RIDER 850 - THE 1988 MODEL

7: X 88.008-26 1.15 5-88

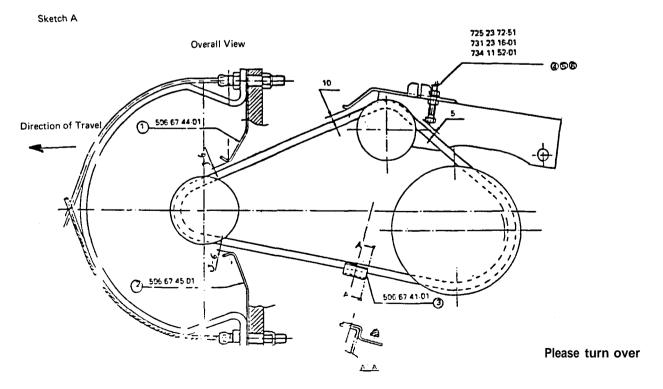
The "1988 model of the Rider 850 features a new gearbox. Since the gearbox has now been reinforced, and has four carrier keys where the old gearbox had only two, the friction in the gear shift mechanism is greater. This can sometimes make it difficult to disengage a gear, especially on a slope. The drive belt tries to become circular when the gears are disengaged, and is thus touching the drive wheels of both the engine and the gearbox. This results in the gear shift mechanism becoming "prestresses" and makes it difficult to engage the next gear.

How to remedy the problem: Fit belt guides as shown in Sketch A. The plates (1) and (2) should be fitted to the fastenings in the steering spindle for the steering cables. A further plate (3) should be fixed to the fastening for the clutch cable as shown in Sketch B. The bolt (4) should be fitted in the groove in the disengagement arm, and then adjusted so that the distance between the head of the bolt and the belt is 5 mm when a gear is engaged. The bolt should be at the same height as the belt.

Fitting these belt guides produces complete disengagement of the gearbox drive wheel, and makes the gears easy to change.

Sketches C and D show the plates that should be fitted to the fastenings in the steering spindle.
